Replacement of 12'6" x 16' recop deck and additional 20' x and deck.

AT 35 Melbourne St

Permit No: Date Applied For: CBL: City of Portland, Maine - Building or Use Permit 04-0232 03/10/2004 015 C022001 389 Congress Street, 04101 Tel: (207) 874-8703, Fax: (207) 874-8716 Location of Construction: Owner Name: Owner Address: Phone: 35 Melbourne St Potter Scott 35 Melbourne St #1 207-797-8661 **Business Name:** Contractor Name: Contractor Address: Phone n/a n/a n/a Portland Lessee/Buyer's Name Phone: Permit Type: n/a n/a Alterations - Multi Family Proposed Use: **Proposed Project Description:** Condominium / Replacement of 12'6" x 16' rooftop deck and Replacement of 12'6" x 16' rooftop deck and additional 20' x 15' additional 20' x 15' deck. deck. **Dept:** Zoning **Status:** Approved with Conditions Reviewer: Marge Schmuckal Approval Date: 03/25/2004 Ok to Issue: Note: 3/24/04 question on height and open outside, exterior stairs - left message with David Leasure 3/25/04 He will fax me a letter - the height is 45' to top of structural beam and the open, exterior stair exists it is being rebuilt up to current codes. - He will apply for a site plan exemption 1) It is understood that the

Re: Structural Design – Rooftop Deck 35 Melbourne Street, Portland, Maine CME Project No. 03-068

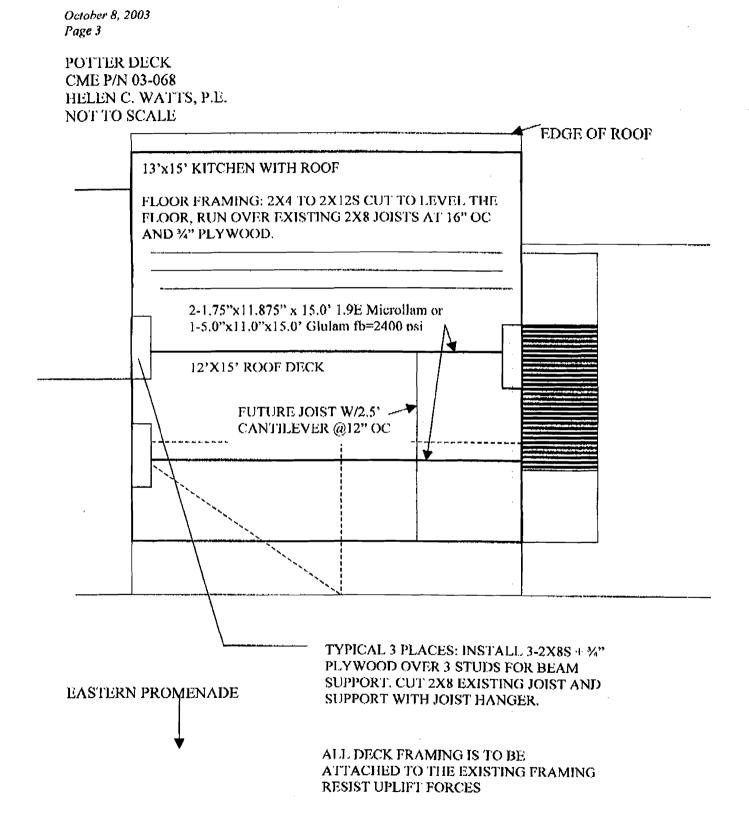
At your request, I reviewed the roof structure of the building at 35 Melbourne Street in Portland, Maine. I visited the building on October 7, 2003. The building is a 3-story, multi-unit apartment building. The building is approximately 90 years old, and was renovated various times.

The roof is a multi-level flat roof and gable with asphalt/fiberglass and rubber membrane roofing. A roof deck has been designed by David Leasure of David Leasure Architects for part of this roof. George Austin of Austin and Sons Roofing was at the building today due to a roof leak. The roof is being removed from the area of the roof deck. Dave, George, and I looked at the condition of the roof and looked at the roof framing to determine the best way to support the roof deck loads, so that the roof leak can be addressed while preparing the roof for the installation of the designed deck structure. The deck structure can then be built without disturbing the rooofing next spring.

The attached sketch shows the framing sizing. I am forwarding this letter to Dave so he can update his drawings as needed, and have called George with the beam sizing so that the roofing can be installed speedily over the added support framing.

We also discussed roof ventilation of the existing deck. Mildew was visible on some of the framing that was exposed when the sheathing was removed. The roof framing generally appears to be in good condition where probed, but the high-moisture conditions causing mildew will eventually cause rot to deteriorate the strength of the wood framing. This deck should be ventilated to prevent a buildup of moisture in the framing. George plans to install 2-inch diameter round vents by sawing through the side framing. This will improve the ventilation of the deck. We also discussed adding two mushroom-cap-type ventilators near the peak of the gabled roof where the original gable end vent was removed. The front gable end vent remains as it was.
